SSD_7417: REGIMENT MIXED-USE REDEVELOPMENT, UNIVERSITY OF SYDNEY, DARLINGTON CAMPUS

ADDENDUM

UNIVERSITY OF SYDNEY RESPONSE TO ADDITIONAL SUBMISSIONS

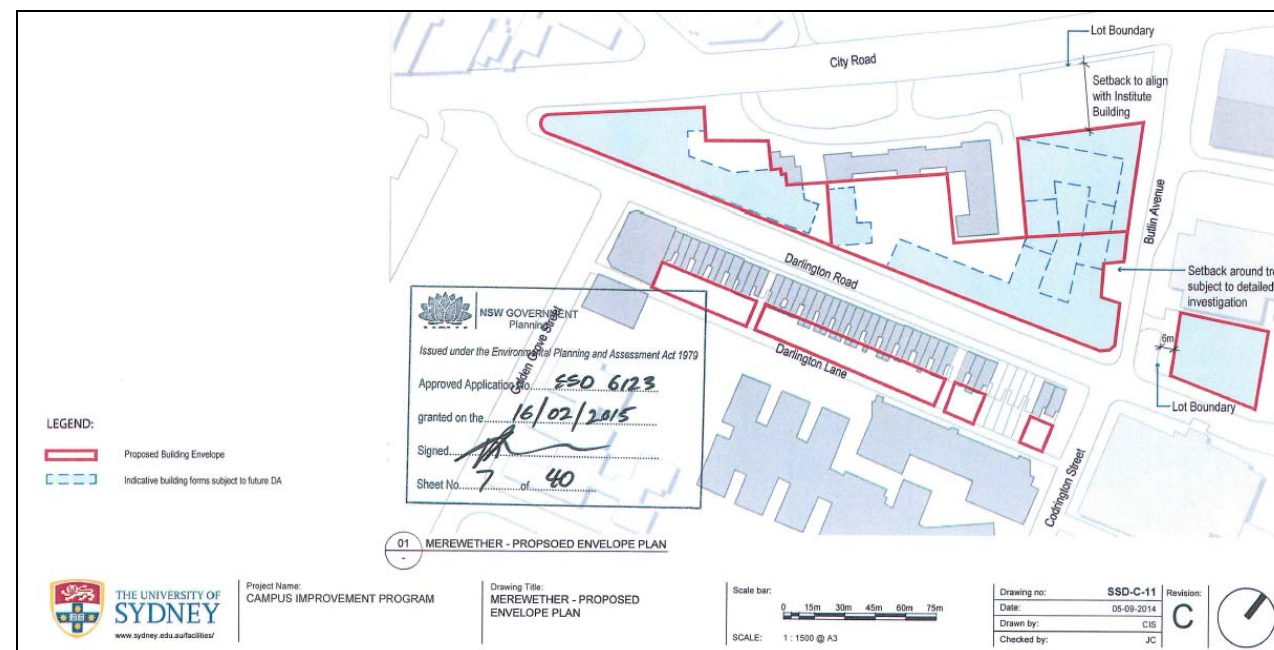
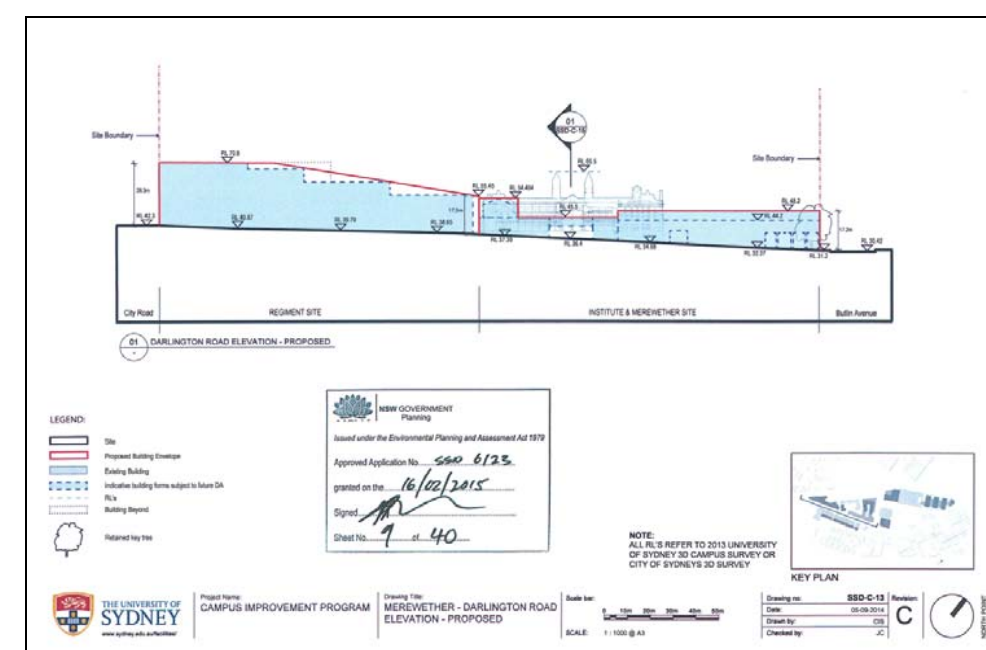
3. Relationship with Superintendent's Building. The new building provides an inadequate curtilage behind the Superintendent's building. The City recommends deletion of part of the building set out between lines 27 and 28 on the plans.

Disagree: The City's objection is inconsistent with the City's position at the pre-DA meeting of 16 January 2017, during which the curtilage of the Regiment Building against the Superintendent's Building, and the SSD photomontage, were both discussed. At that meeting City's representatives supported the relationship of the Regiment building against the Superintendent's Building.

The height of the Regiment building behind the Superintendent's Residence drops from 6 storeys to 4 and, combined with the materials and colours proposed, will ensure that the new building is recessive and will not visually overwhelm the Superintendent's Residence. Nor will it affect the more significant and adjacent Institute Building.

Approved CIP Plan SSD-C-11

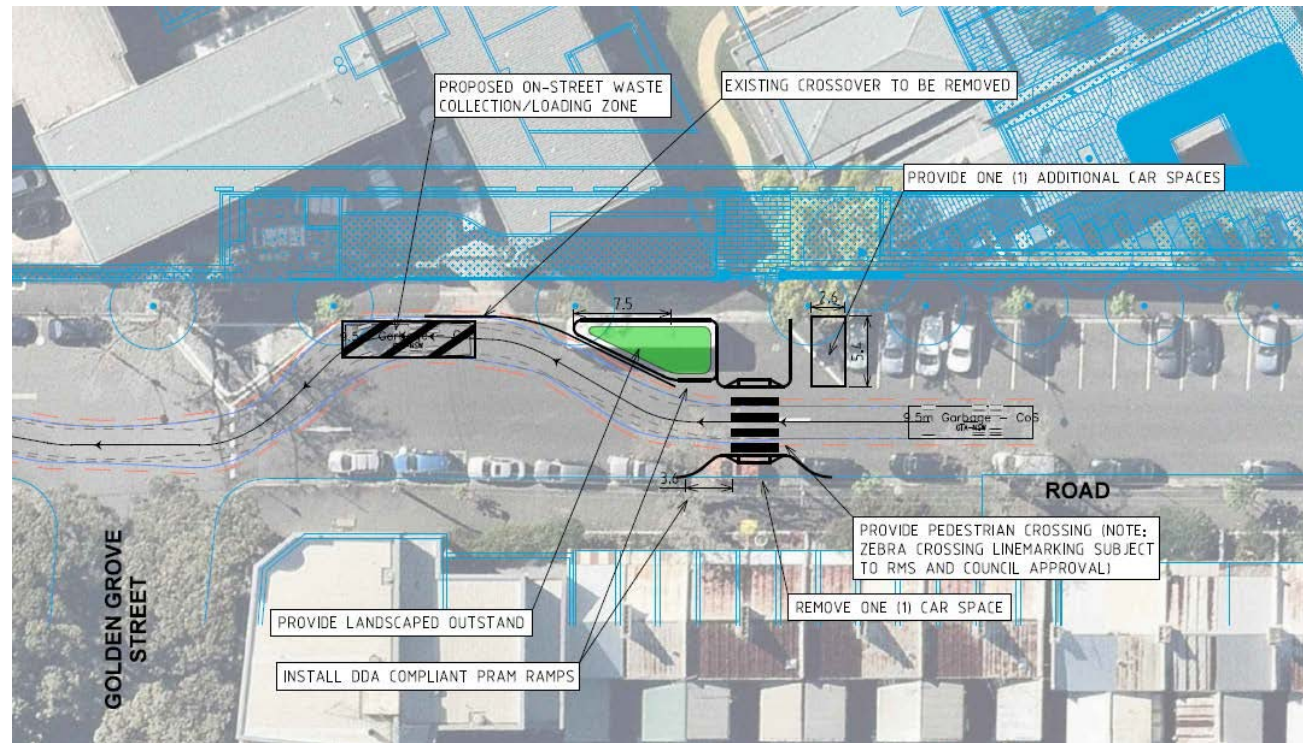
SSD 7417 – REGIMENT MIXED-USE REDEVELOPMENT	
HC ISSUE	USYD PROJECT RESPONSE
The Heritage Council reiterates: - The proposed Regiment Building should be setback, at least to align with the architectural plan grid coordinate no. 35 from the current grid coordinate no. 37. - The Regiment Building's form should be reduced to increase the visual separation between it and the Institute Building.	Disagree: Refer to the University's original RtS submission page 25. This Regiment SSD proposal only partly occupies an approved Stage 1 Concept State Significant Development Application (SSD 13_6123) building envelope for the <i>Campus Improvement Program (CIP) - Merewether Precinct</i>, as approved by the Minister for Planning on 15 February 2015 (see excerpt below). The CIP building envelope was approved following consideration of appropriate urban design and heritage solutions affecting the site and also allows for further development behind the Institute building. The CIP Merewether Precinct building envelopes were the subject of significant comment during the Stage 1 DA. Ultimately, all of the comments provided by the Heritage Office and the City of Sydney in relation to the envelope associated with the Regiment Building (Envelope No.1 as shown the DPE's assessment Report) were considered and amended by the University in our final Response to Submissions as part of the Stage 1 DA process. These amendments to the CIP envelope were endorsed in the DPE's assessment report where (on page 23 of the Assessment Report) it stated: <i>'The Department's assessment has been finalised based on the final design as detailed in the RtS and RtS supplementary response. The Department is satisfied that the Response to Submissions Report, supplementary RtS report and the additional information have appropriately responded to issues raised and provides a sound basis for an appropriate merit assessment. Key issues have been further considered in Section 5 of this Report.'</i> Any further setback of the proposed building behind the curtilage of the Superintendent's building will have negligible visual effect to the Regiment and future adjoining CIP projects, and would result in the unnecessary deletion of additional affordable student accommodation and community facilities. The University does not support the proposed setback.

Furthermore, the University also highlights that the Regiment SSD proposal only partly occupies the approved Stage 1 Concept State Significant Development Application (SSD 13_6123) building envelope for the *Campus Improvement Program (CIP) - Merewether Precinct*, as approved by the Minister for Planning on 15 February 2015 (see plan excerpts overleaf). The CIP building envelope was approved following consideration of appropriate building footprints and heights, urban design analysis, and justification on heritage impacts and solutions affecting the site and surrounding buildings. As demonstrated overleaf, the building envelope also allows for further development expansion behind the Institute Building.

The CIP Merewether Precinct building envelopes were the subject of significant comment during the Stage 1 SSDA. Ultimately, all of the comments provided by the Heritage Office and the City of Sydney in relation to the Regiment building envelope (Envelope No.1 as shown the DPE's assessment Report) were considered and amended by the University in our final Response to Submissions as part of the Stage 1 DA process. These amendments to the CIP envelope were endorsed in the DPE's assessment report where (on page 23 of the Assessment Report) it stated:

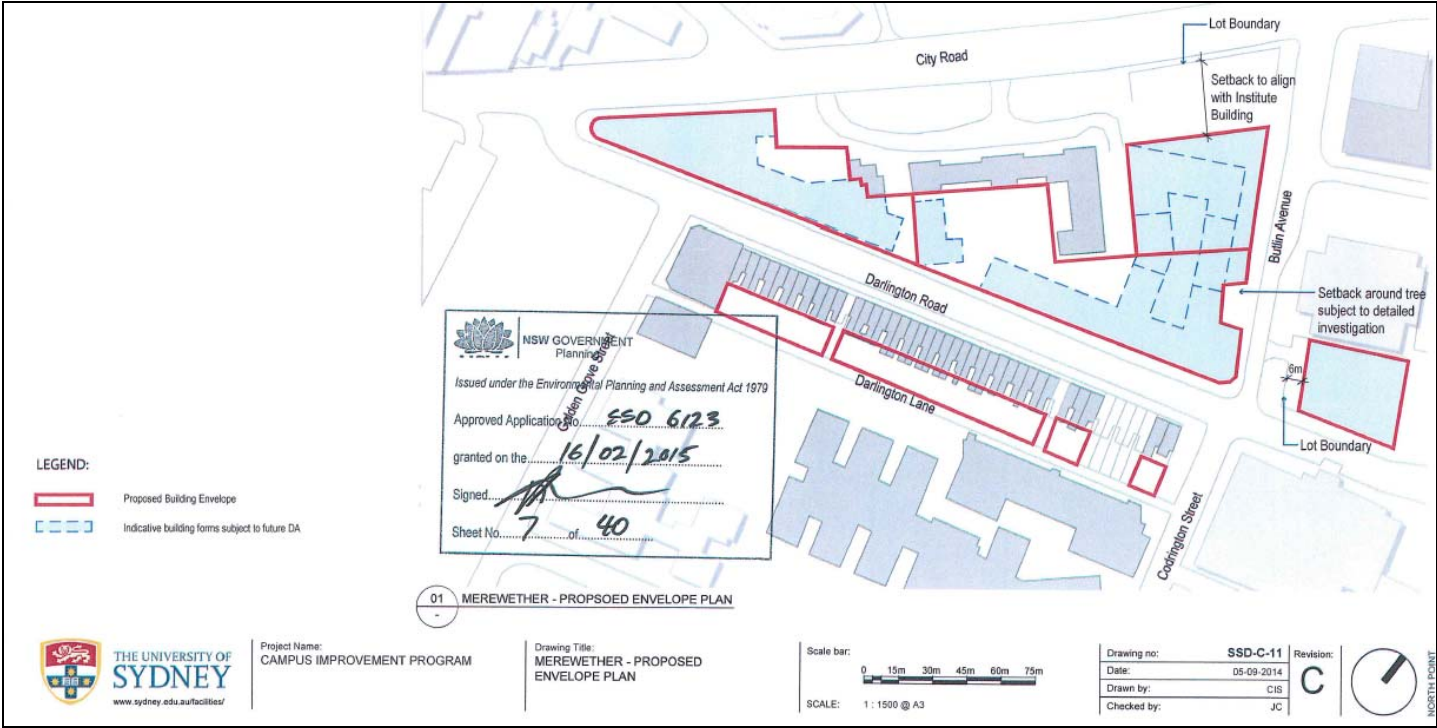
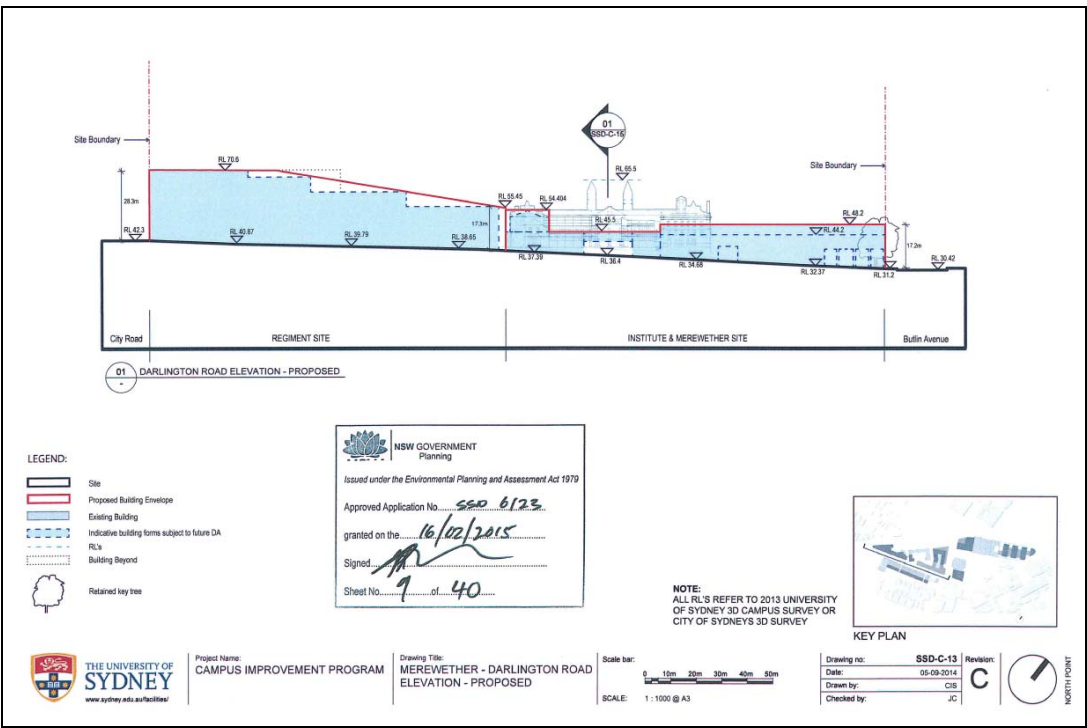
10. Pedestrian crossing – to be located directly at the intersection with Golden Grove Street and not setback along Darlington Road.	Disagree: The location and reasoning of the proposed crossing is discussed in Section 4.2 and Section 5.2 of GTA's Transport Impact Assessment Report Revision D dated 16 February 2017 The University stands by its original location for a proposed pedestrian crossing. The location represents a safe and controlled pedestrian environment, setback from the fast and busy traffic movements typically experienced at the junction of Darlington Road and Golden Grove Street. This pedestrian crossing location will be directly in front of the Regiment Building's new site access fronting Darlington Road as illustrated in figure 4.1. It will also provide a direct and legible pedestrian connection to the "publicly accessible pathway" across the Regiment site to City Road. This proposed location responds positively to the City's concern about the legibility of the proposed pedestrian visibility of the "publically accessible pathway". The associated loss of 1 (one) car space on the southern side of the Darlington Road can be offset by the provision of 1 (one) additional 90-degree car space on the northern side of Darlington Road.
